## Huron WMD Complex Clarifications 002:

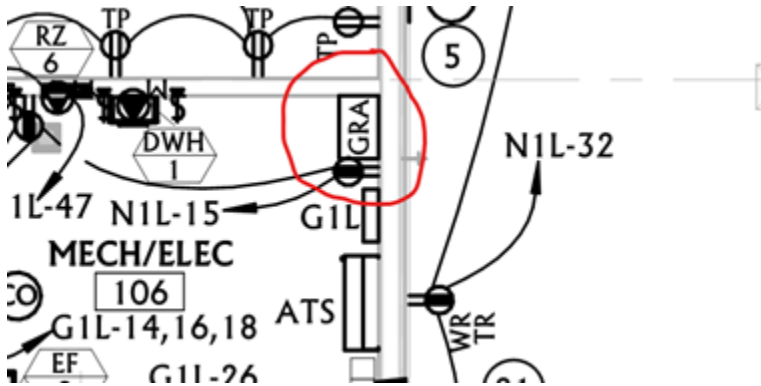
- 2.) Plan sheet E101 is this a clerical error on drawings?
  - a. [Clarification: This is an artifact in the drawing. Please ignore.](#)
